CITY OF NORTH PORT

CONTRACT/AGREEMENT AMENDMENT FORM

Project Name: MCWTP Structural Rehabilitation Phase 1 – Flocculation Tank No.1 Repairs

Subject: RFI No. 002-2 (ZEP)

Pictures Provided to CDM Smith on July 20, 2020

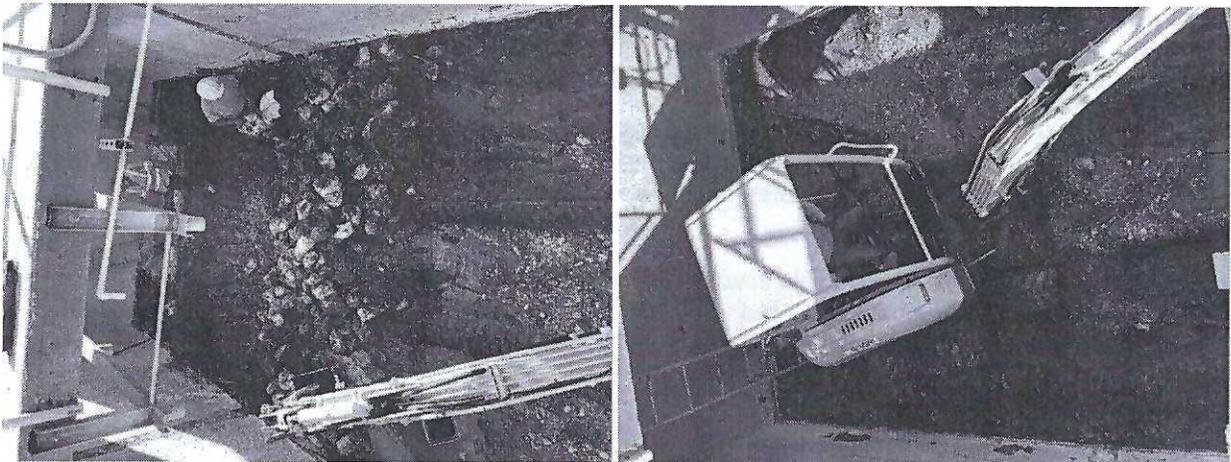
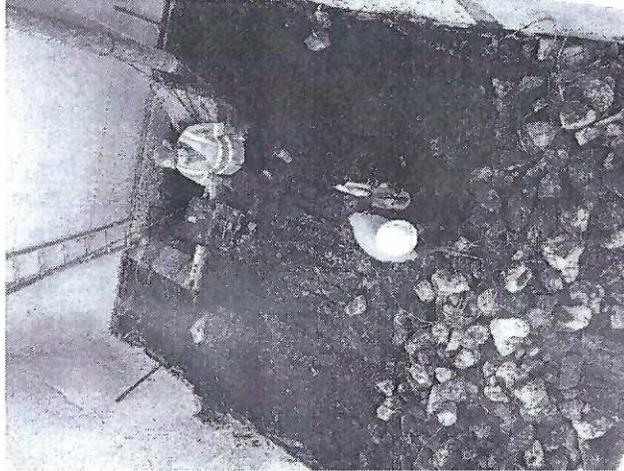
The subgrade appears to be disturbed and unsuitable for re-use. Subgrade conditions under the slab of floc tank #1 are suspected to offer poor support and warrant detailed overlook.

CDM Smith recommends replacing the existing soils in the subgrade below the slab. The contractor shall replace approximately 3 (three) feet of subgrade below the slab by completely excavating it and replacing it in accordance with either A) or B) below. Excavated soils and materials shall be disposed off-site and or stacked on-site by the contractor as directed by the City. All other requirements shall be in accordance with the contract agreement (submittals, review and approvals)

- A) Excavate and replace minimum of 3 feet of the soil with structural sand fill compacted to 98% of the Modified Proctor maximum dry density. Our recommendation is based on the limited information made available and hence needs to be confirmed by the Contractor's geotechnical engineer. The Contractor shall hire a geotechnical engineer to provide recommendations for restoring the slab subgrade to a suitable condition for construction of the new slab. Future slab loading is assumed to be similar to that which has occurred over the last 60 years of tank operation. The Contractor's geotechnical engineer shall perform at least 6 hand augers and dynamic cone penetrometers to a depth of 5 feet and provide documentation of the existing condition of the subgrade soils beneath the proposed new slab. Engineering recommendations shall be provided for restoring the condition of the slab subgrade including potential near-surface soil replacement of the disturbed soil, acceptable structural fill, total depth of compaction whether new fill or existing soils and compaction criteria.

- B) Remove the existing subgrade and replace with flowable fill in lieu of the proposed soil investigations listed in A) above. CDM Smith can approve this approach after the contractor performs the following:

- 1. Excavate fill to the top of the existing concrete footing; no further so as not to potentially undermine the wall footings.

2. Recommend using a flat excavator bucket to facilitate removal of existing fill without further disturbing the subgrade at the top of the footings.
3. Perform a minimum of three (3) overlapping passes on the existing subgrade with plate compactor.
4. Replace with excavatable flowable fill per FDOT Section 121. The maximum unit weight shall be limited to 100 lb/ft³.
